**MARION TOWNSHIP PLANNING COMMISSION
AGENDA**

SUBJECT: Schroeder's Body Shop Amended Site Plan

Combined Revised and Final Site Plan Review for Marion Township Planning Commission

RE: Schroeder's Body Shop
Final Site Plan Review

USED CAR DISPLAY PARKING DETAIL

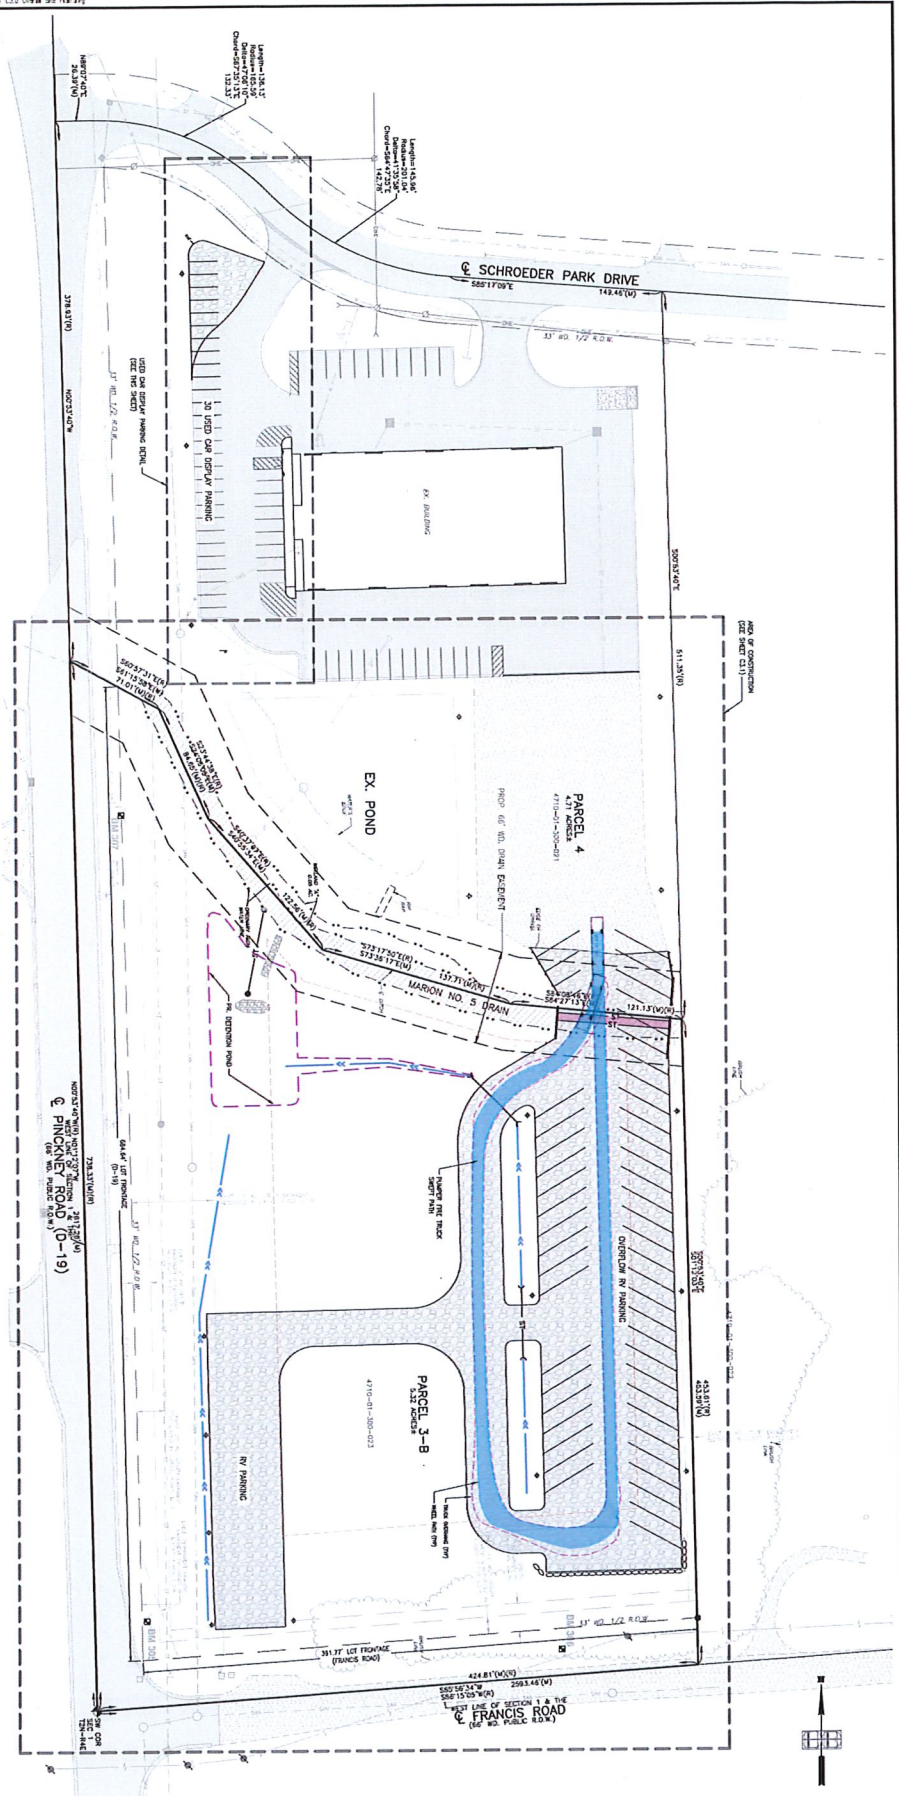
The site plan notes the spaces for used car display parking will be 20 feet deep by 9 feet wide. The minimum width for parking spaces with 90-degree orientation is 10 feet. These spaces need to be widened.

SCHROEDER'S PARKING EXPANSION
PARCEL 3-B
PARCEL 4
MARION TOWNSHIP, LIVINGSTON COUNTY, MI
ANNUED SITE PLAN
STORM WATER MANAGEMENT PLAN

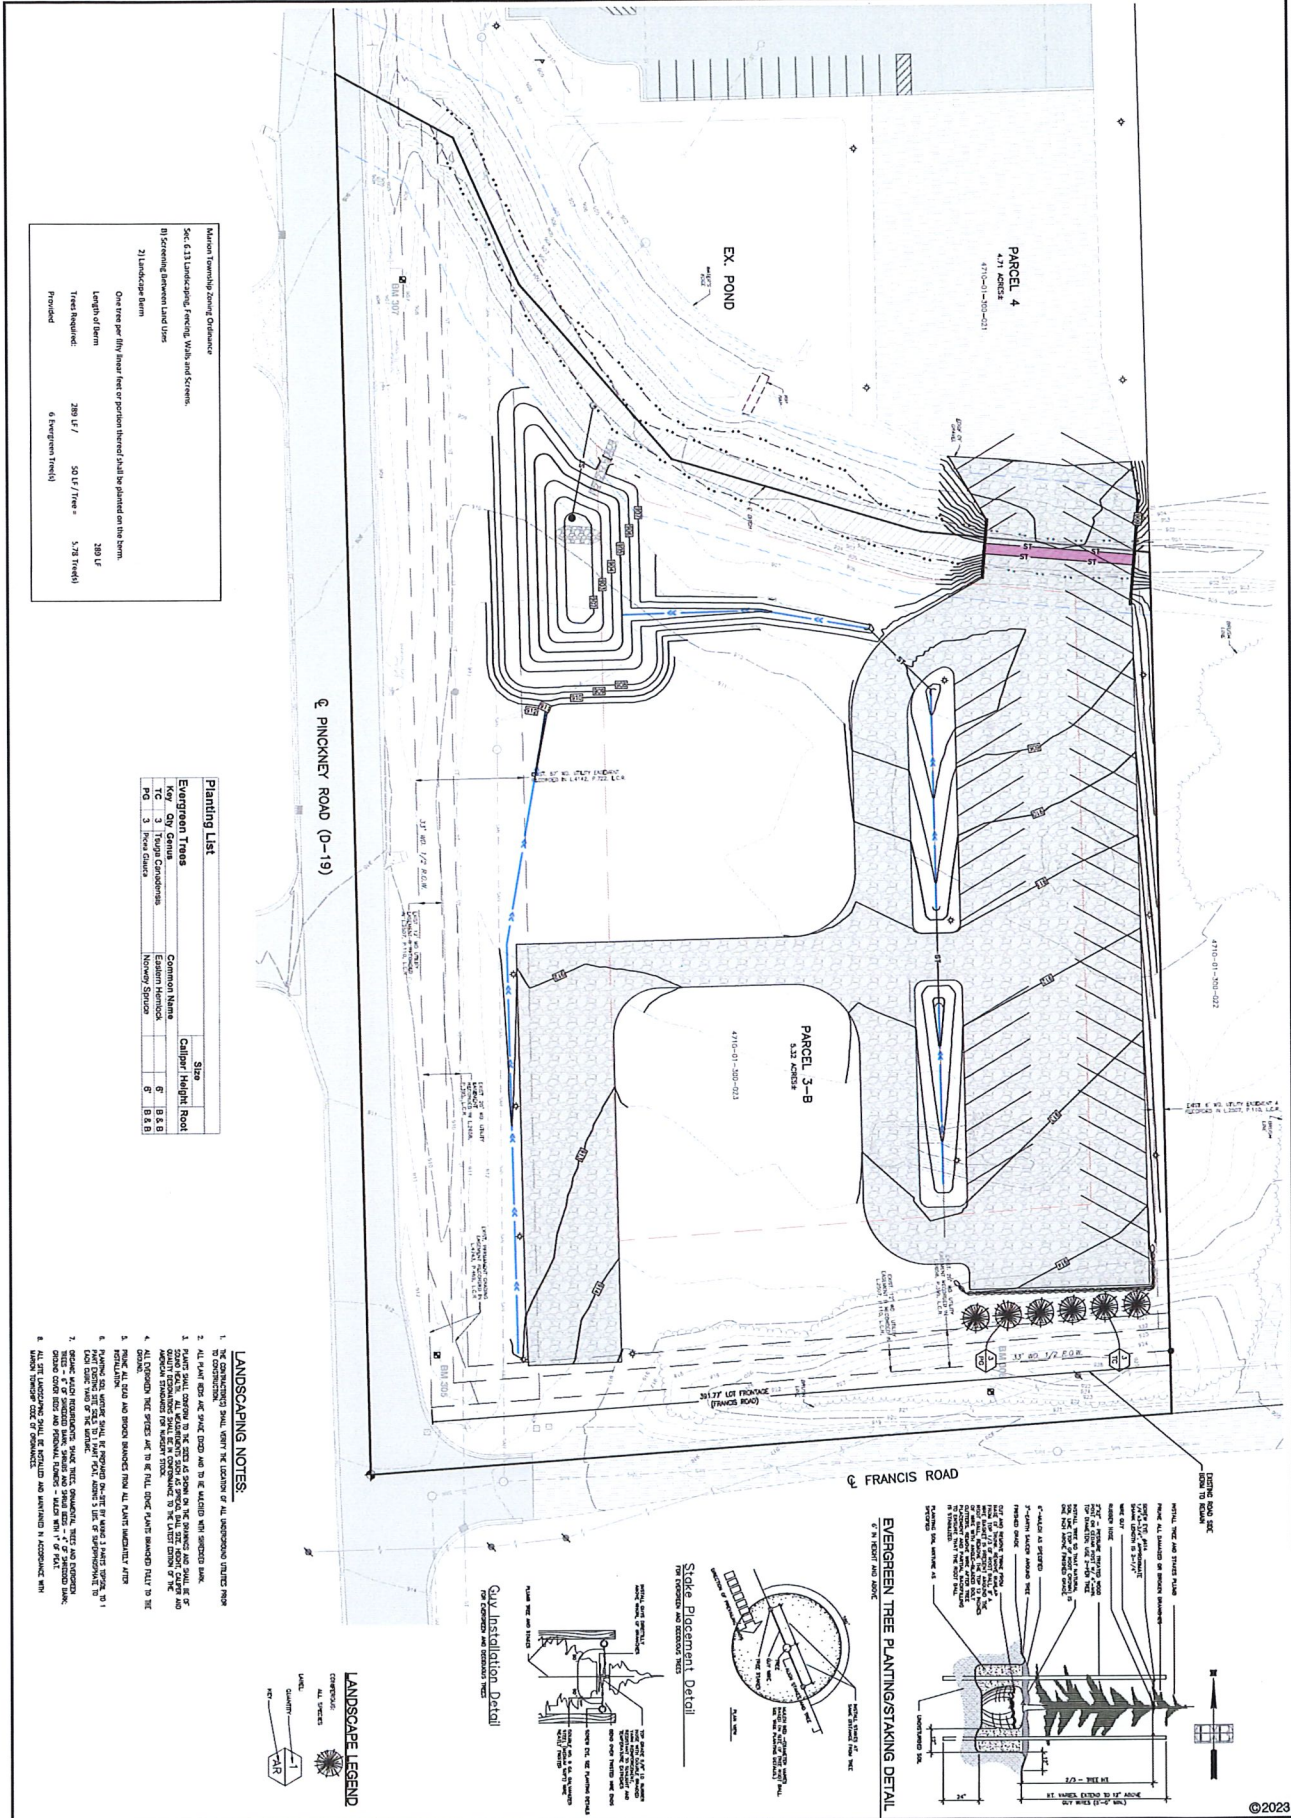
The proposed storm drainage system includes swales that drain the RV storage lot via culverts to a stormwater detention basin. The parking lot access will require crossing the Marion No. 5 drain and enclosing a 100' portion of the drain. A 60" HDPE corrugated plastic culvert is proposed for the enclosure. Enclosing a drain is a significant undertaking and proper study must be performed to ensure the pipe does not restrict flow and cause upstream flooding. No data has been provided on the site plan related to the existing drain capacity or the proposed culvert capacity. We request this data be shown to verify the site can be constructed as shown.

Water is released from the detention basin via a standpipe draining to the Marion No. 5 drain along the northern property line. The drain easement extends 8' beyond the top banks of the drain. The engineer should note that the soils in this area are known to be unstable and should plan accordingly.

The engineer should verify that the vehicle roadside display area is included in the detention pond drainage area. The grading indicates this parking area drains toward the basin via sheet flow but there are no storm sewers, culverts or swale shown that demonstrate flow being directed to the basin. It appears some of the display area may drain toward the ditch along D-19. Sheet flow is acceptable as long as the appropriate runoff volume is detained and treated within the site.

We did not perform a detailed review of the calculations on Sheet C6.0 as I trust Spicer will be doing that task as part of their normal site plan review.

1. Please indicate on the plans the existing drain capacity and the capacity of the proposed culvert for the drain enclosure.
2. Please verify that runoff from the proposed vehicle roadside display area will be captured in the stormwater management system.
3. Please provide the drain easement requested by LCDC
4. Please verify the drain bottom at the detention basin discharge pipe as requested by LCDC.
5. Please provide a soil erosion control plan.
6. Please clarify if the gate and drive approach will be removed in the area of the vehicle storage display.
7. Please reduce the light levels at the property line near the retirement home.
8. Please clarify the lighting intent for the vehicle roadside display and update the photometric plan accordingly.
9. Please provide permits or approvals from:
 - a. LCDC
 - b. EGLE
 - c. Howell Area Fire Department

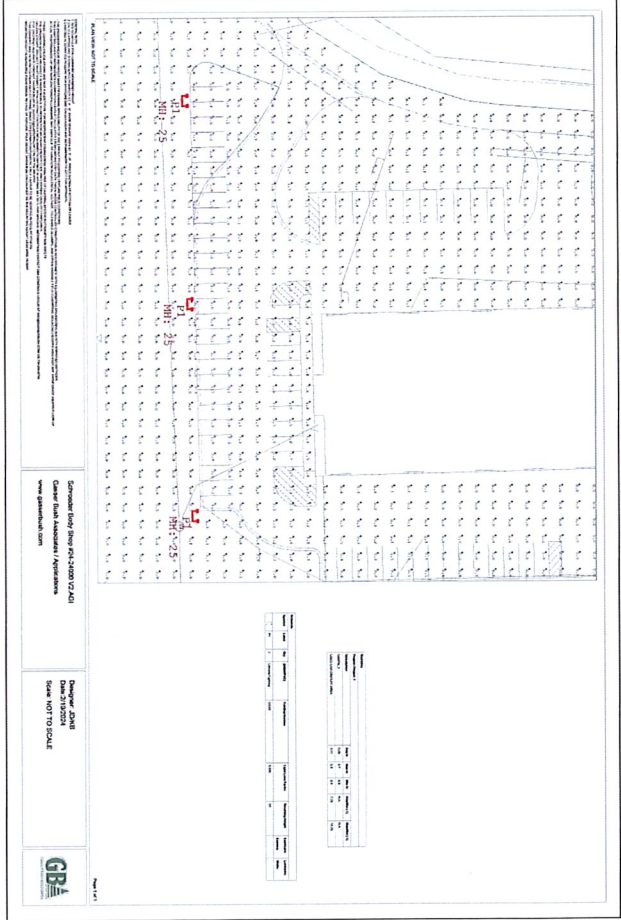
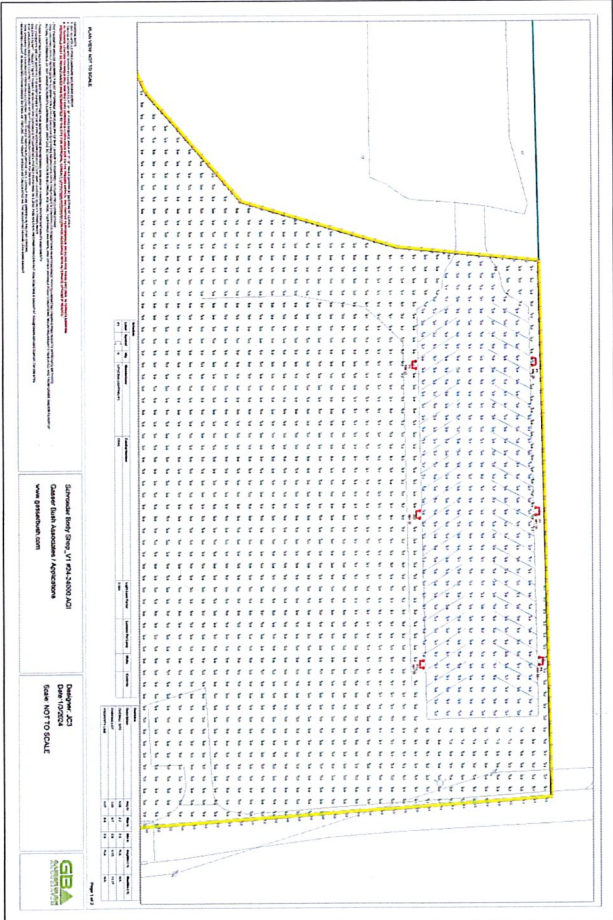
The lighting plan also includes specifications for Gefolloy solar street lights. Five of these fixtures are shown around the vehicle display area on the southern portion of the site, but they are not shown on the photometric plan. These fixtures are not full-cutoff and would create glare and project light onto adjacent properties or roads. They should be replaced with another fixture type.

The proposed fixtures would use light emitting diodes. The Zoning Ordinance, §14.014(E)(2) requires high-pressure sodium, which has a color temperature of 1900K to 2000K. The Planning Commission may approve alternate luminaires that use "warm white or natural lamp colors," but the color temperature should be 3000K or less.

Lighting is proposed around the perimeter of the RV storage lot and at the front of the existing building along D-19 (used car display area). The proposed light fixtures are solar powered LED. The provided photometric plan shows the average light level of the used car display area to be 3.1 footcandles (fc) with a max of 5.9 fc. The light levels at the property line in this area are generally 0.0 fc, which is acceptable. The provided map does not show all the way to the corner of Shroeder Park and D-19 and the light levels in this area are slightly above zero, but this should not create any problems as the levels are quite low.

Items to be Addressed: Photometric plan to be revised as noted above. Planning Commission guidance on whether it would consider an alternate light source in place of high-pressure sodium.
